STREET A PLAN AND
PROFILE

PARKER RIDGE
82 SCHOOL STREET
ROLESVILLE / NORTH CAROLINA / 27571

08/01/2023 PER TOWN OF ROLESVILLE COMMENT

STREET F PLAN AND PROFILE

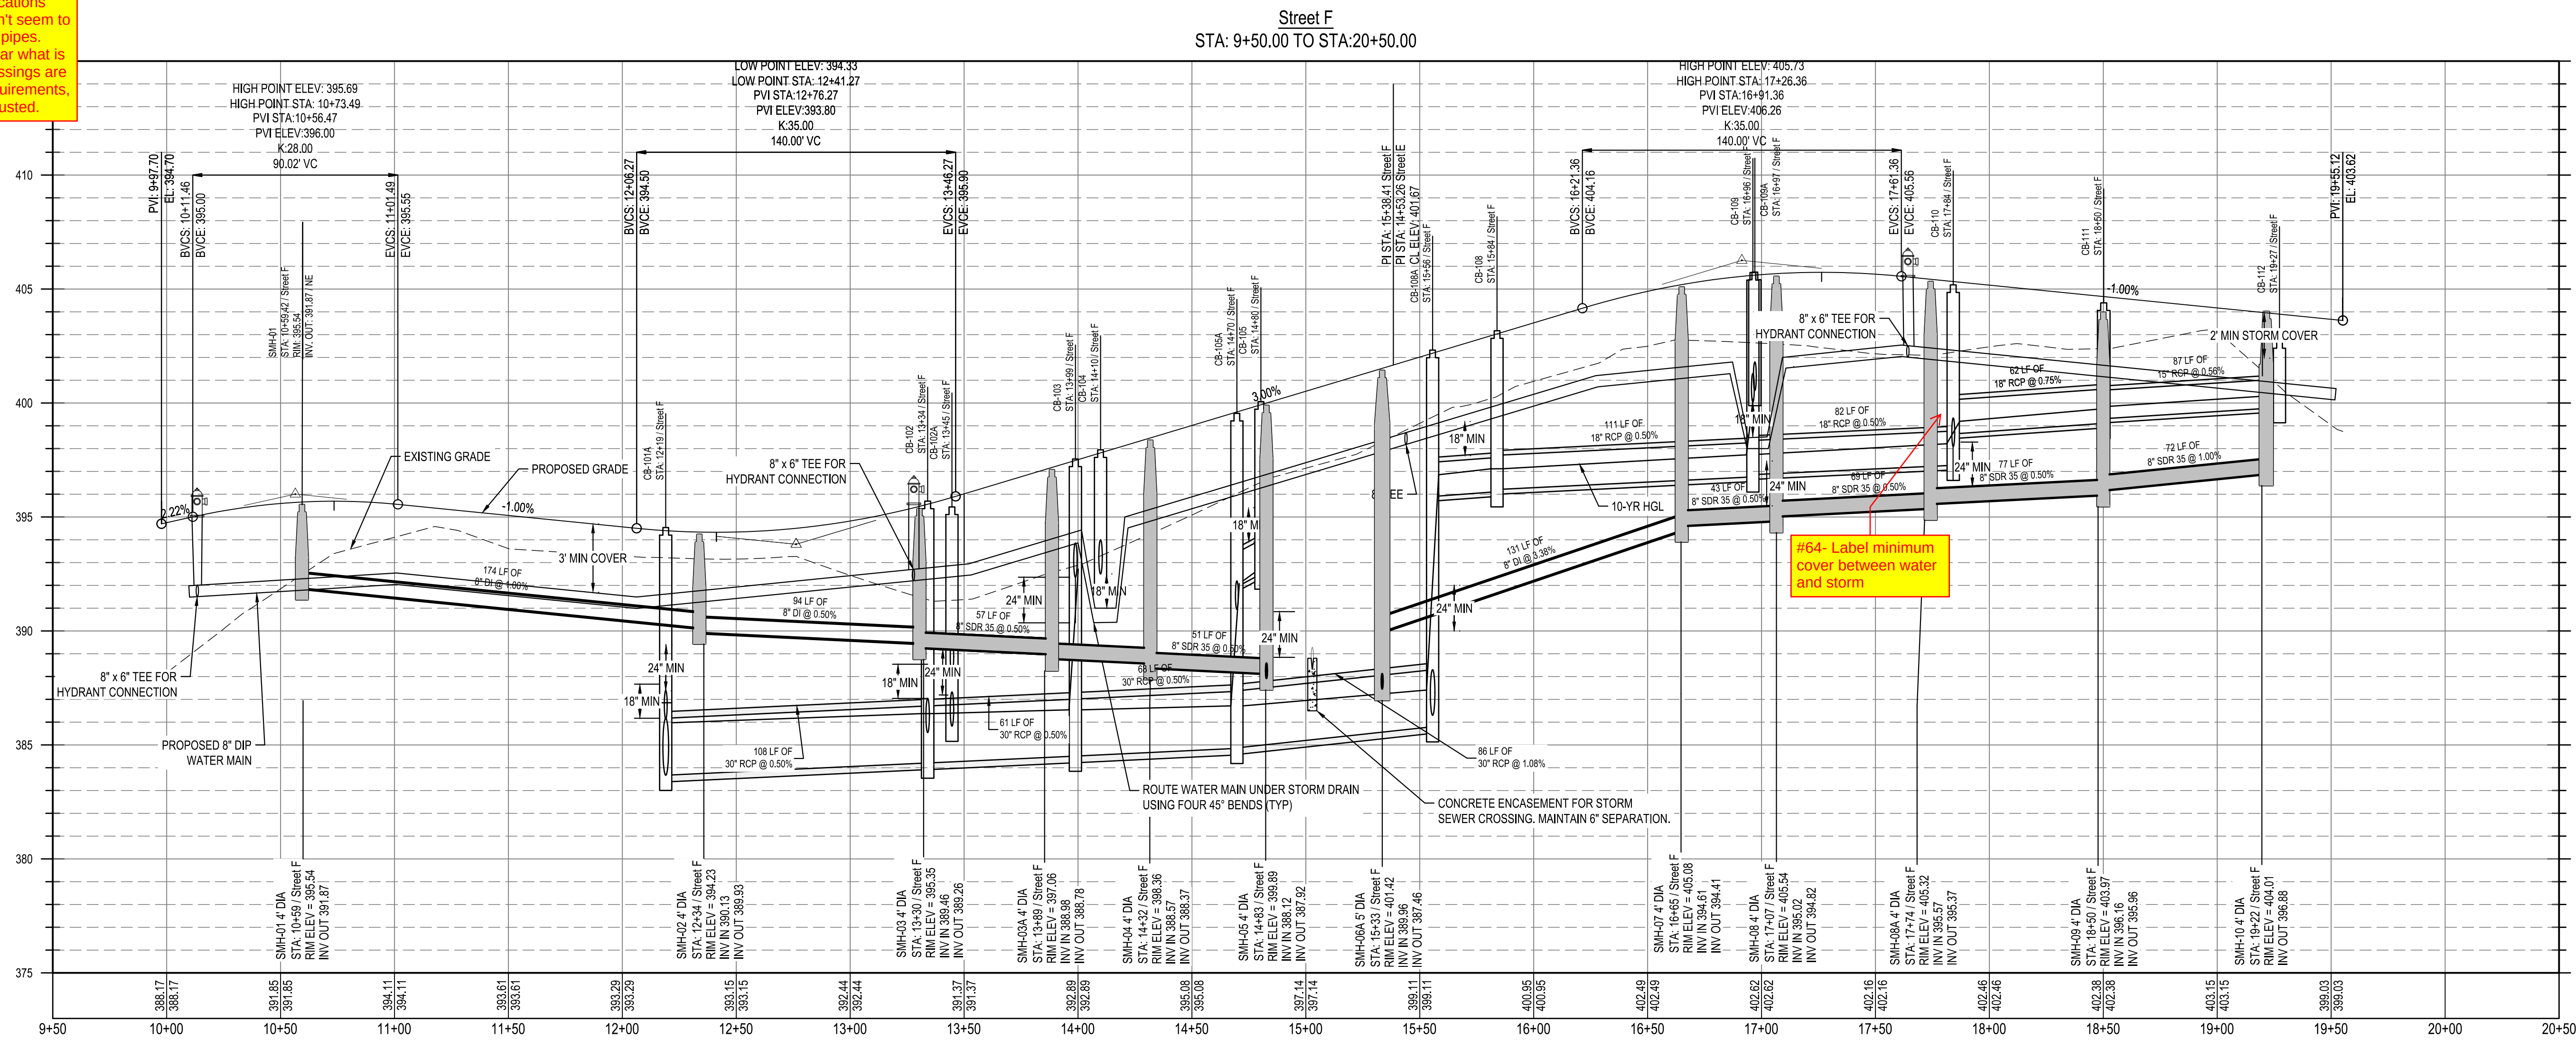
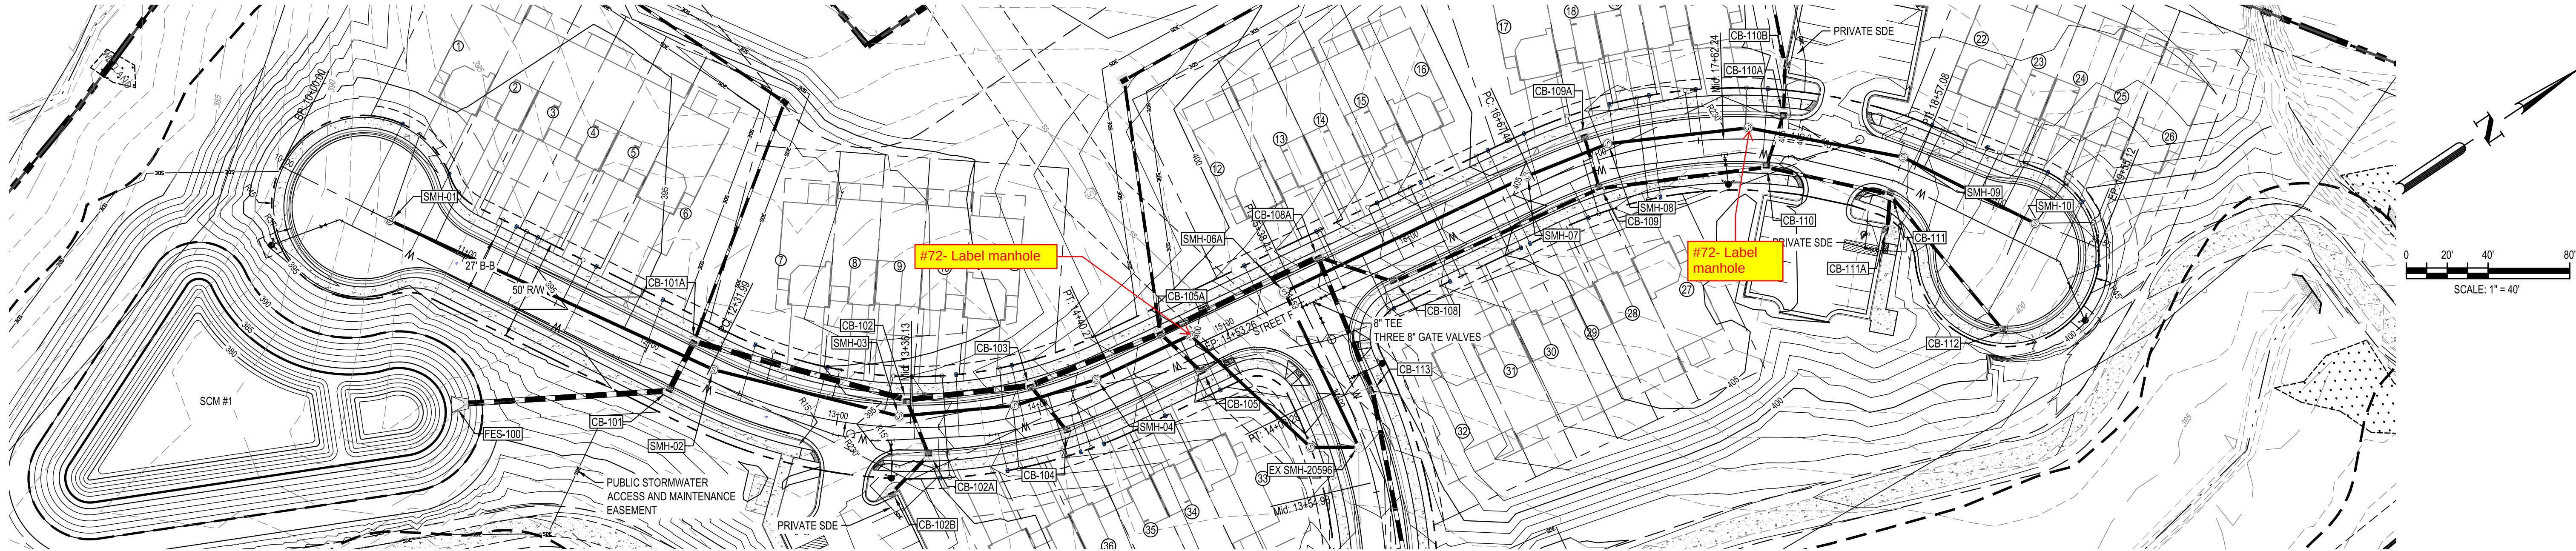
#64- Label minimum cover between water and storm

#72- Label manhole

#72- Label manhole

Street G
STA: 9+50.00 TO STA:19+00.00

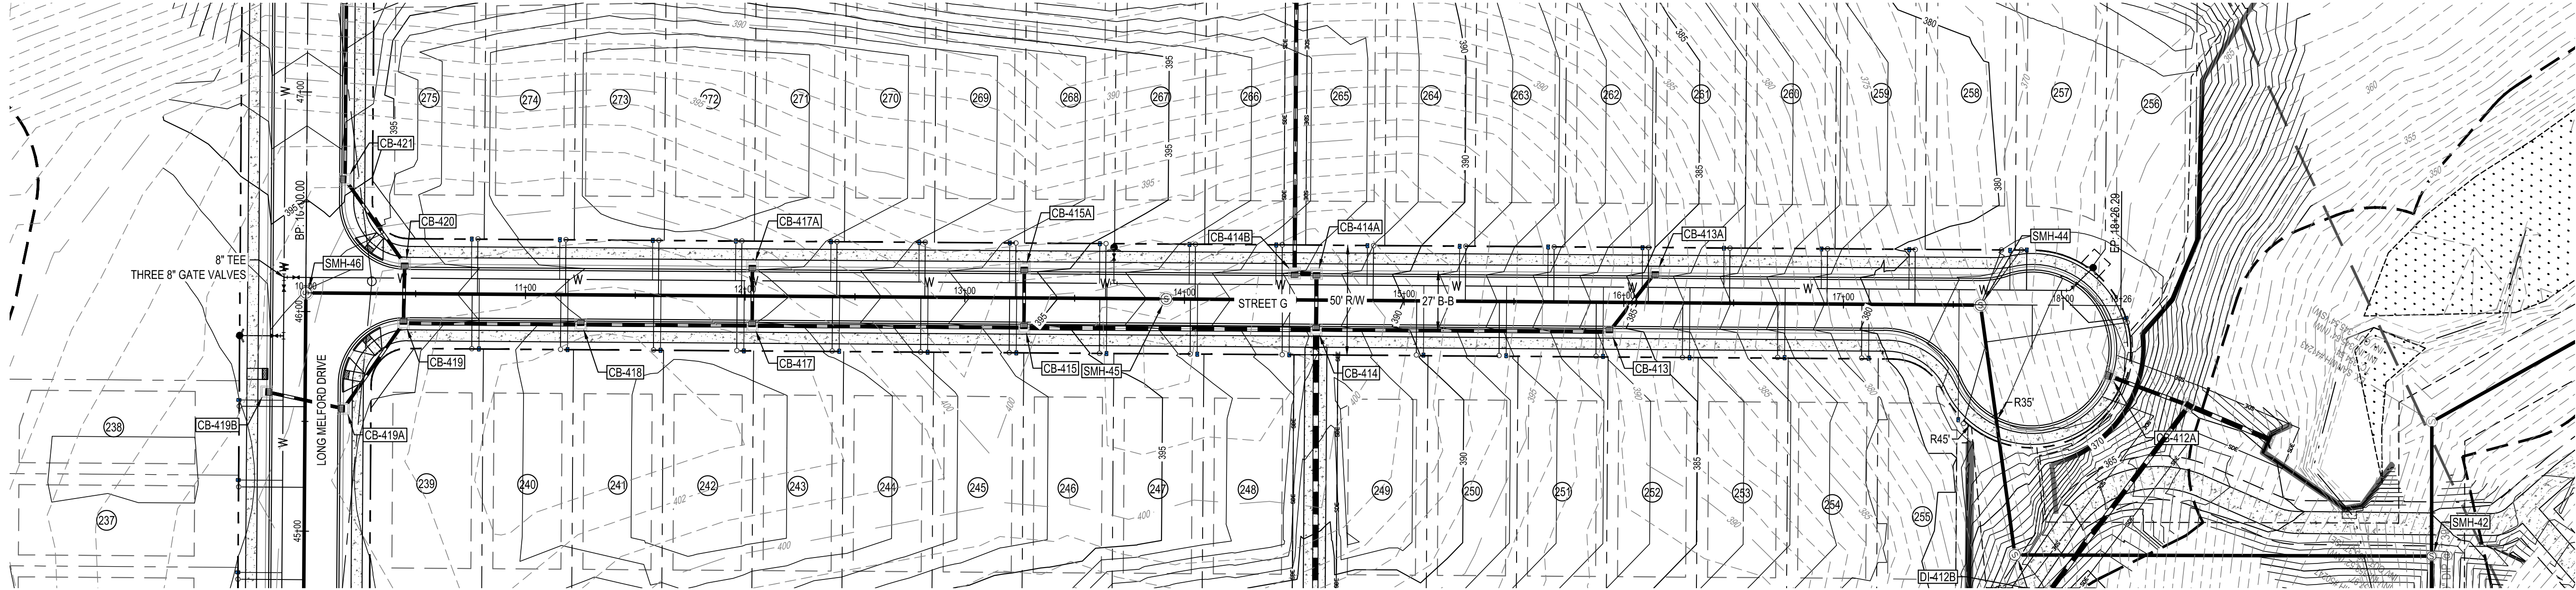
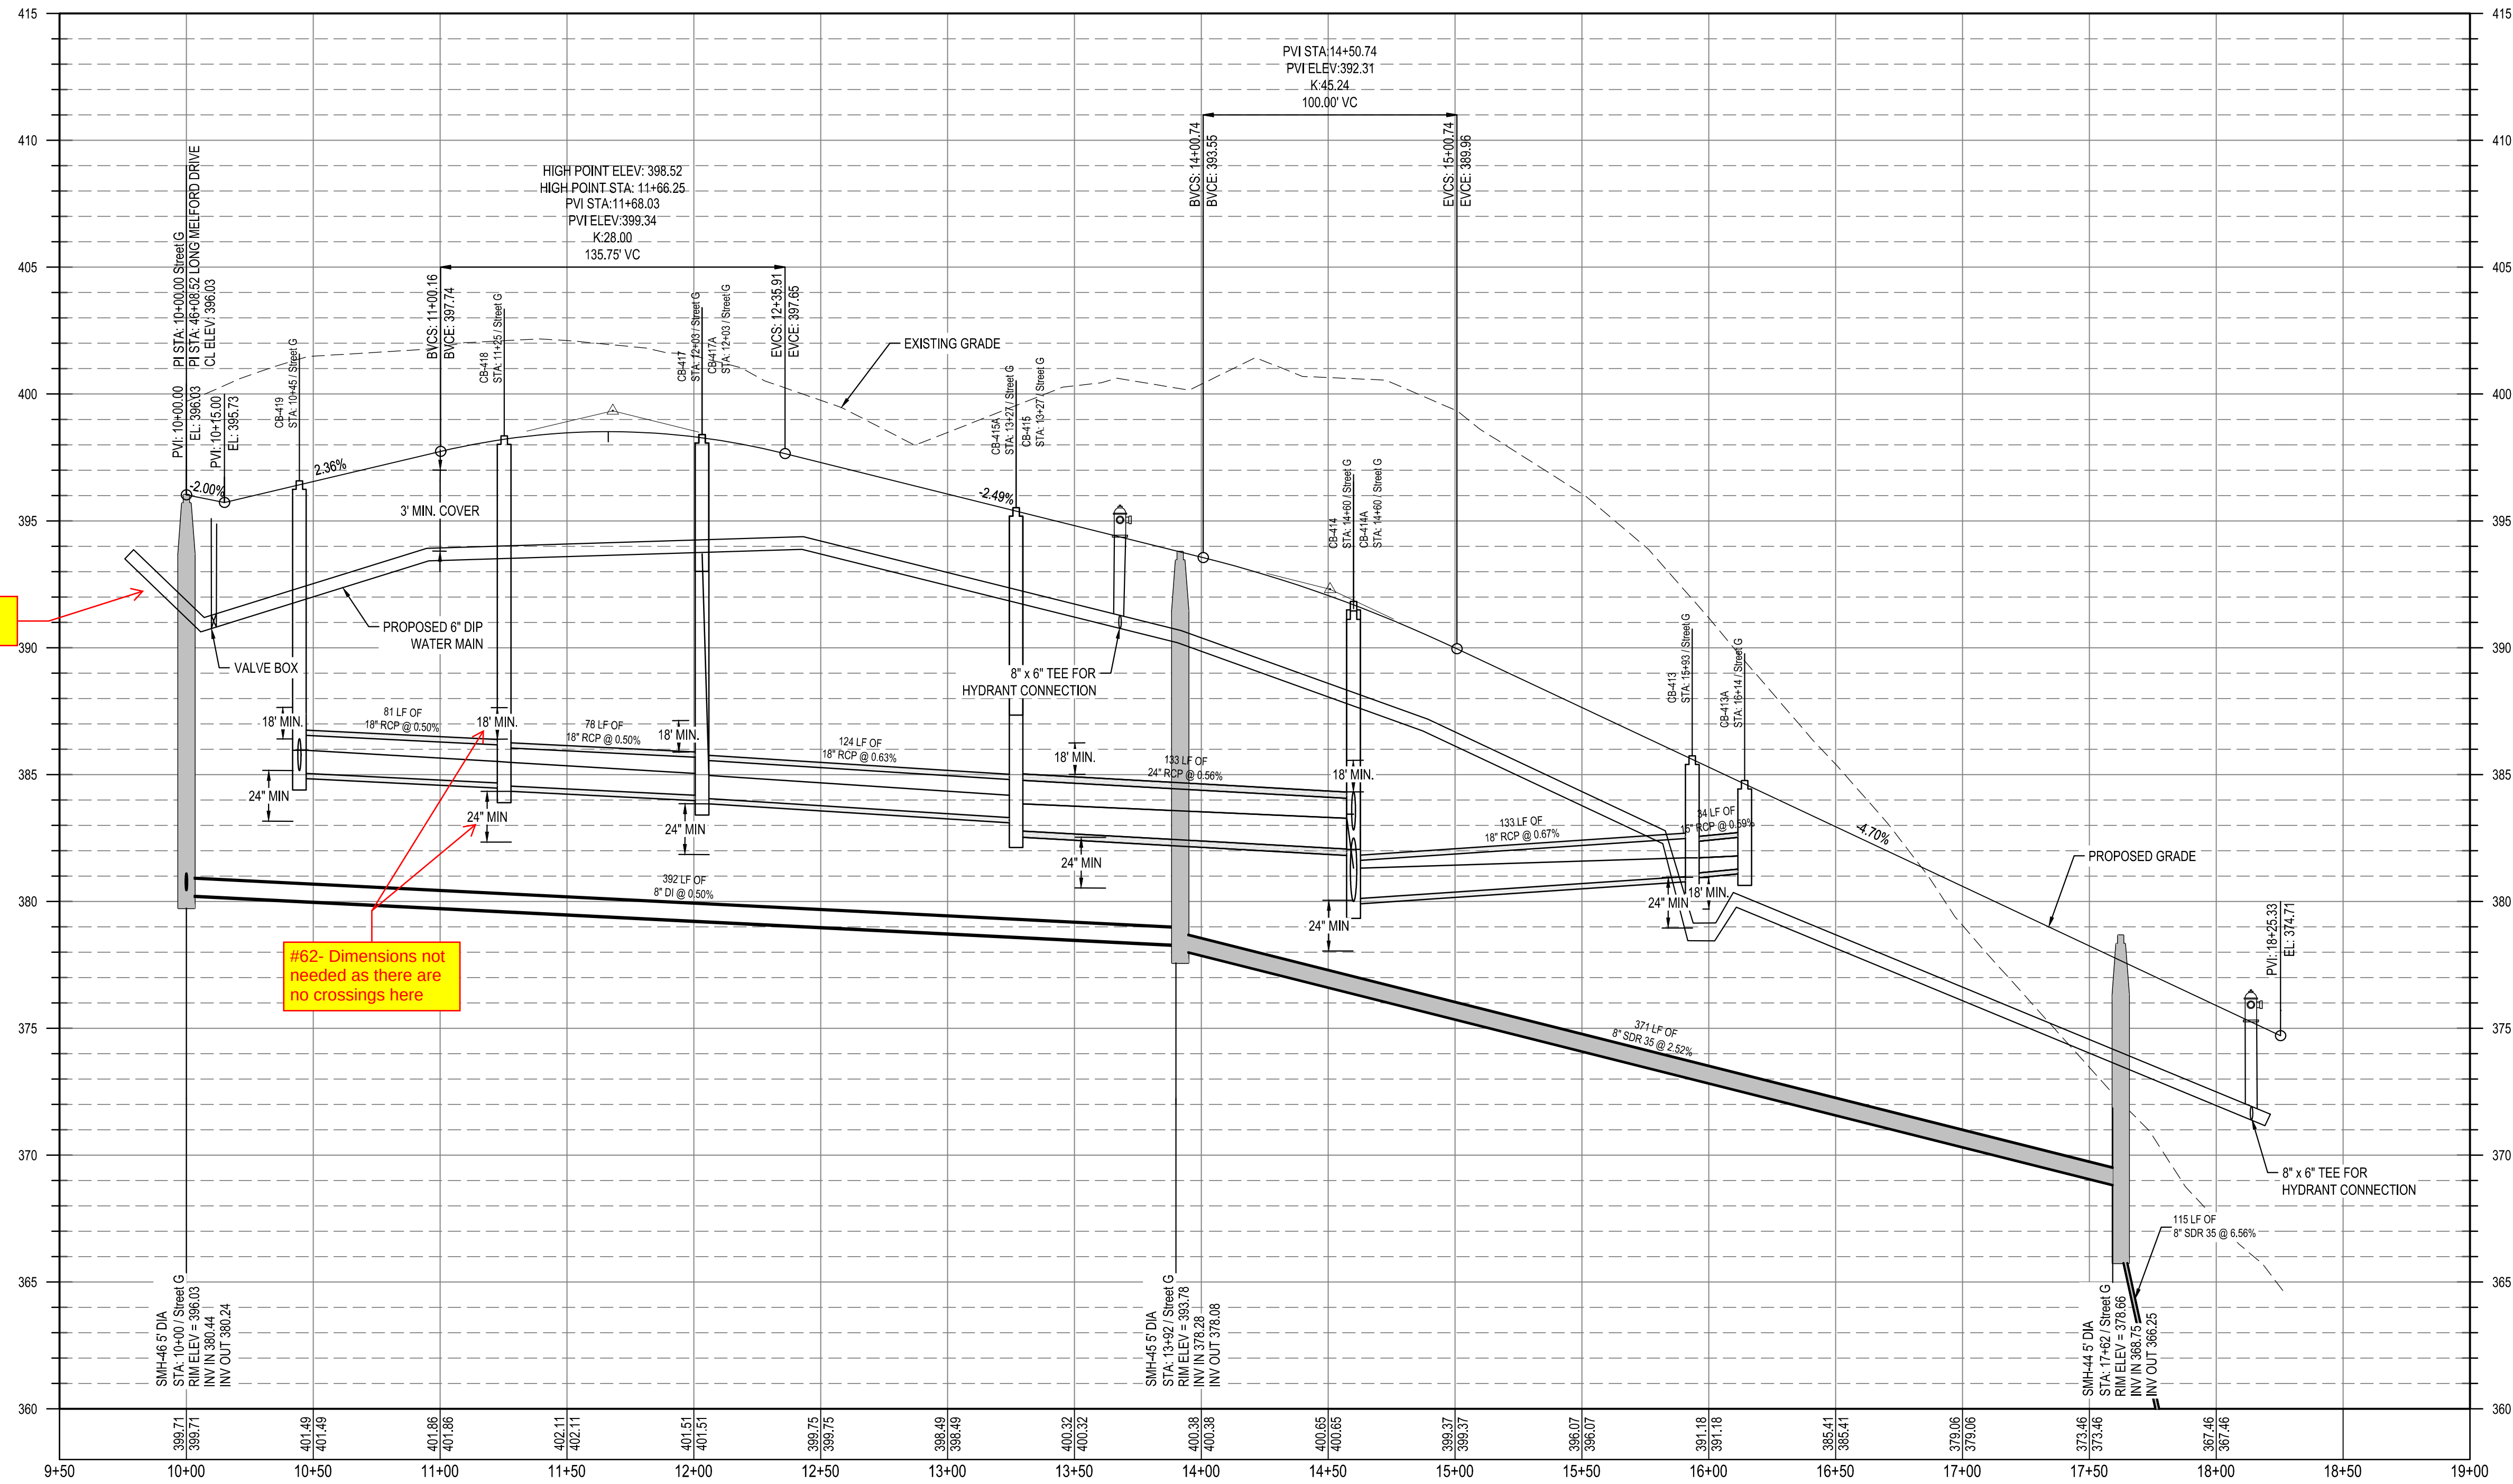
#73- show and label tee

#62- Dimensions not needed as there are no crossings here

#62- There are several locations where the dimensions don't seem to line up with top/bottom of pipes. Please make sure it is clear what is being dimensioned. If crossings are not meeting minimum requirements, design will need to be adjusted.
